**RECLOSING BLOCKING AUXILIARY RELAY**

**0208A8419**

**TYPE NAA RELAY**

FIG. 1 (0246A3664) Internal Connections For 0208A8419

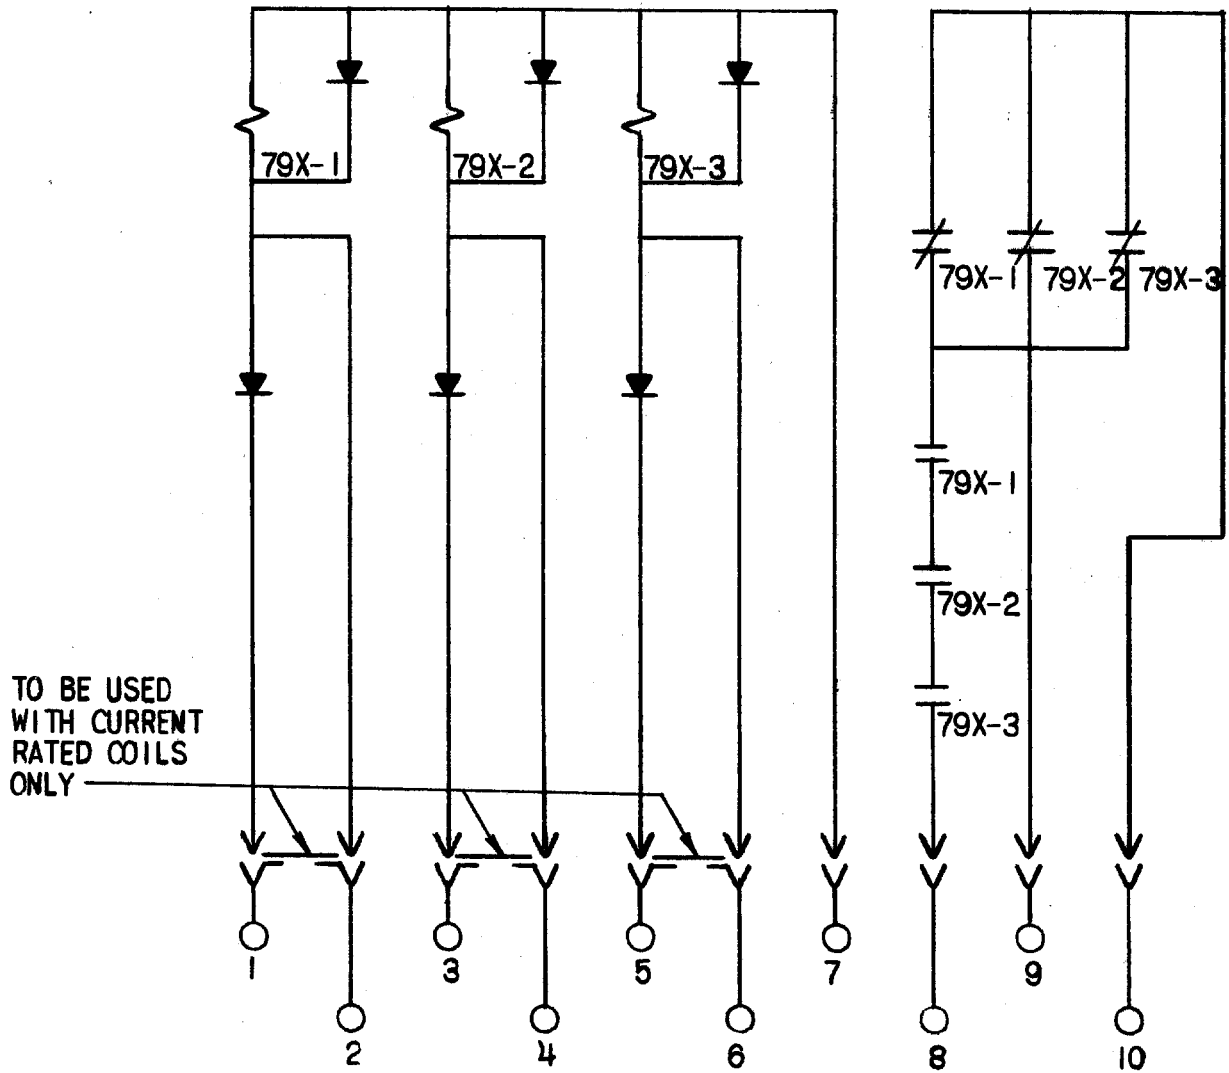
1. Relay unit 79Y is omitted.
2. Relay units 79X1, 79X2, and 79X3 will pick up in 8 milliseconds and drop out in 33 milliseconds or more.
3. The internal connections are as shown in figure 1 of this supplement.
4. The capacitors in parallel with the tripping diodes have been omitted at the request of the customer. This omission will decrease the relay's resistance to high voltage transients.
